ANNEXATION REPORT & STAFF REPORT

The Bluffs 9th Filing Summation

CASE NUMBER: Annexation-12-00003

The Bluffs 9th Filing

The subject property is outlined above. Shaded areas are unincorporated land.

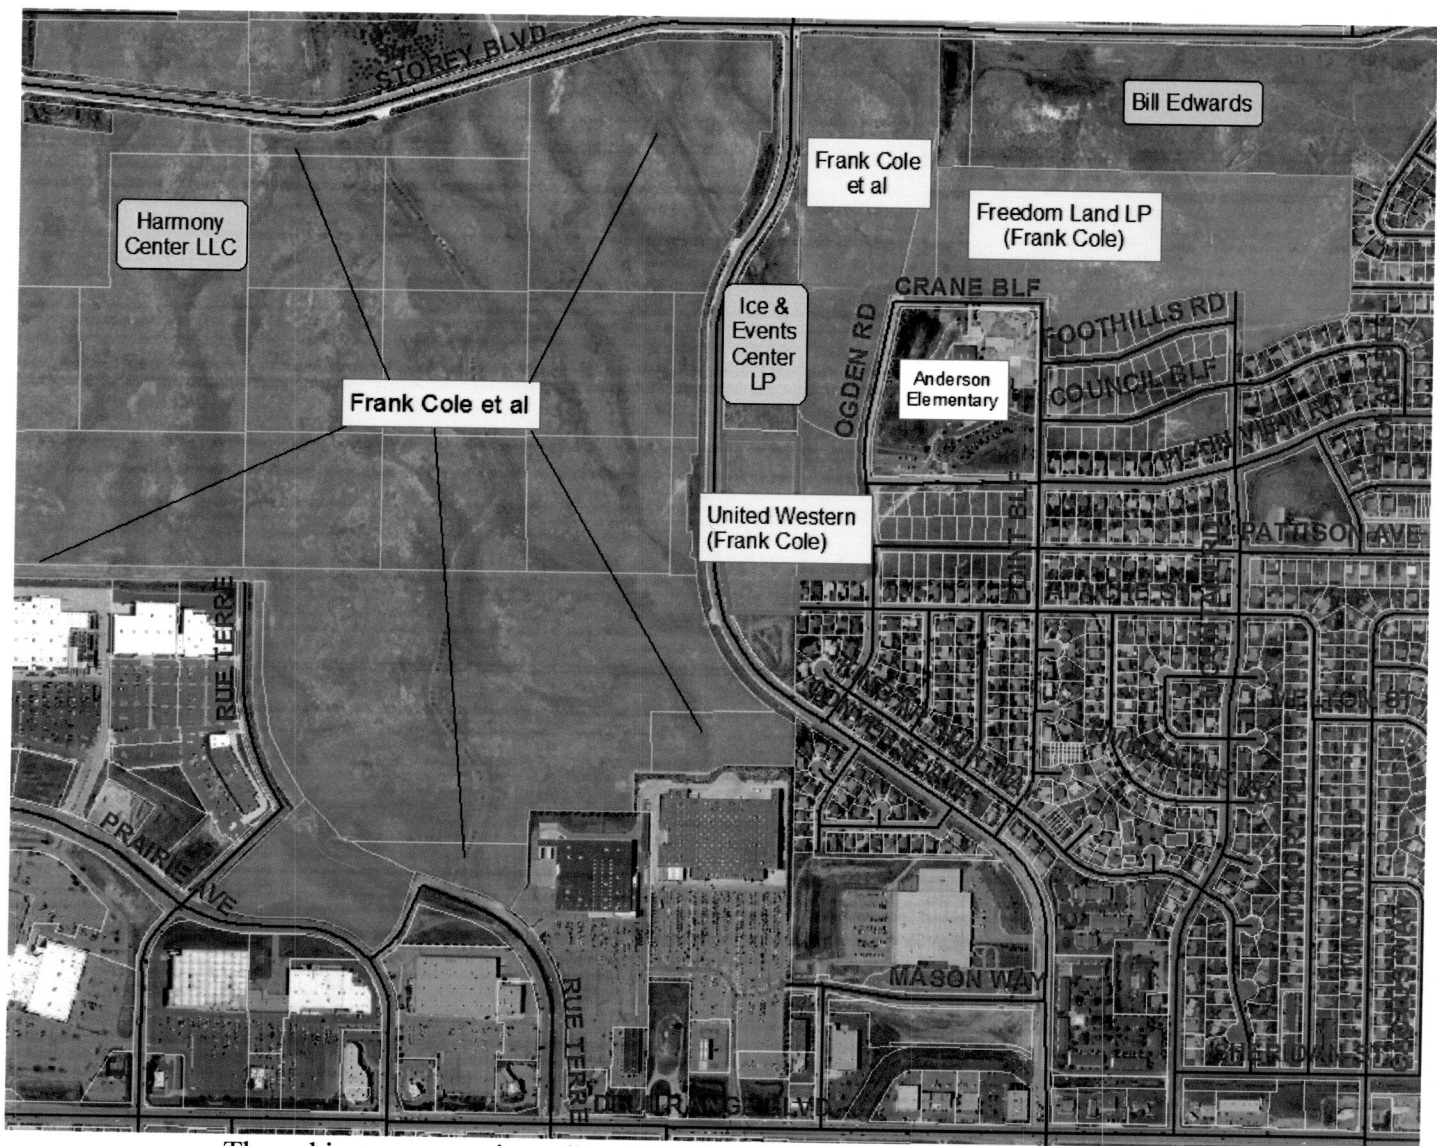
The main concern with the annexation is that it is a piecemeal annexation that excludes adjacent property under the same ownership for no apparent reason. The adjacent land is proposed to serve as stormwater detention for a portion of the proposed development on the subject property.

1. The application does not reflect extension of the street connecting Converse Avenue to Ogden Road. Half of the street has already been platted by the City with the platting of the parcel to the north. Extending existing platted streets is required (UDC § 4.3.3.f). The street is also referenced in the transportation master plan and critical for the provision of a four-way intersection onto Converse Avenue.
2. The application claims an existing detention pond as an exception to the open space requirement, but the stormwater detention pond in question does not have sufficient capacity and design standard to serve the proposed development. The open space provided in the proposal does not appear to meet the open space requirements (UDC § 4.4).
3. Stormwater run-off for part of the proposed development would be addressed with a detention pond that is outside the City's jurisdiction.

The proposed plat contains 28 buildable lots. The plat proposes to utilize a city maintained stormwater facility south of the site and the stormwater facility east and north of the site recently developed in the County mentioned above. The proposal terminates Apache Street and Pattison Avenue into a cul-de-sac and proposes no access onto Converse Avenue.

**ANNEXATION
MAP
FOR
THE BLUFFS
9TH FILING**

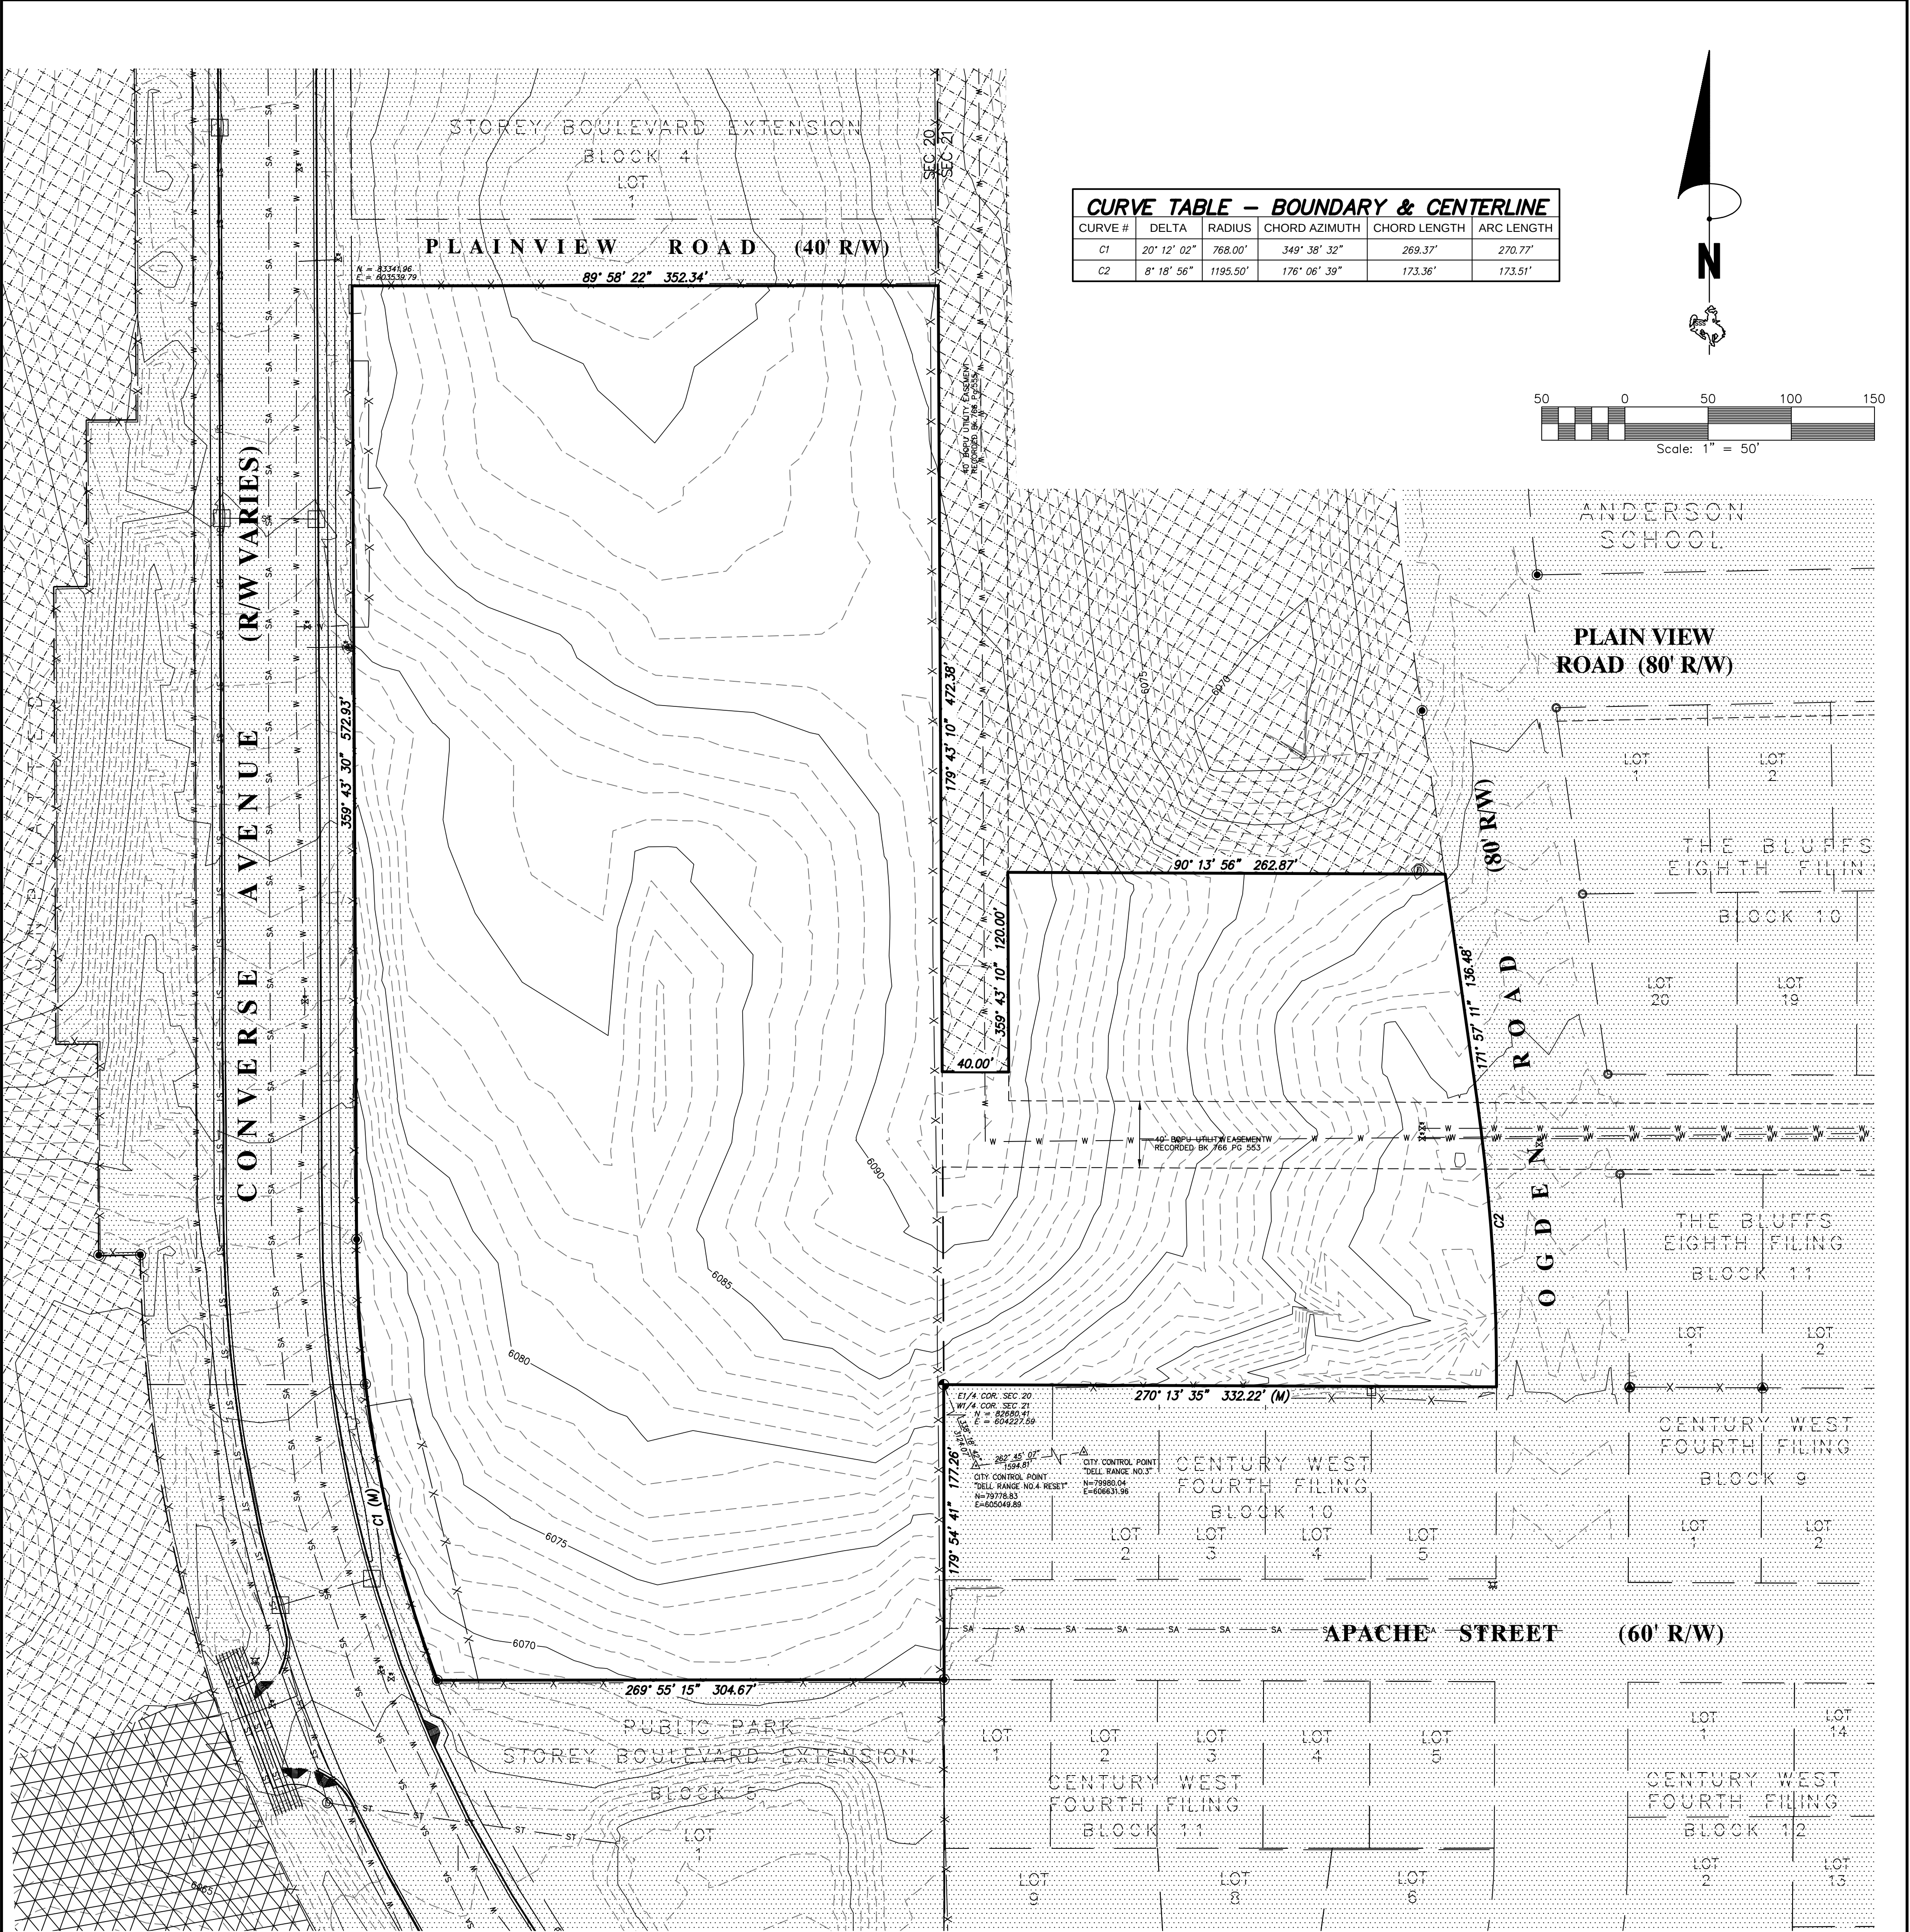
1. The azimuths and distances provided in the LAND DESCRIPTION do not match those found on the map drawing. Therefore I cannot determine which set of figures should be used for properly identifying these boundaries. This correction is required prior to approval.
2. In the LAND DESCRIPTION involving Section 20, the degree symbol appears to not be properly turned on. This correction is required.

This annexation area should be expanded to include the detention pond and water main easement located between this annexation area and Ogden Road. It would be preferable to see all of the developer's land located east of Converse and south of Storey annexed at this time. Doing so would simplify jurisdictional questions like arose earlier this year with the Ogden Road detention pond and facilitate future phases of the Bluffs.

Recommend the existing stormwater detention pond between Ogden Road and this 9th Filing also be included in the annexation.

The detention pond that was recently constructed should be annexed with this development. To leave it within the County sets up the possibility of an unincorporated island parcel surrounded by city parcels.
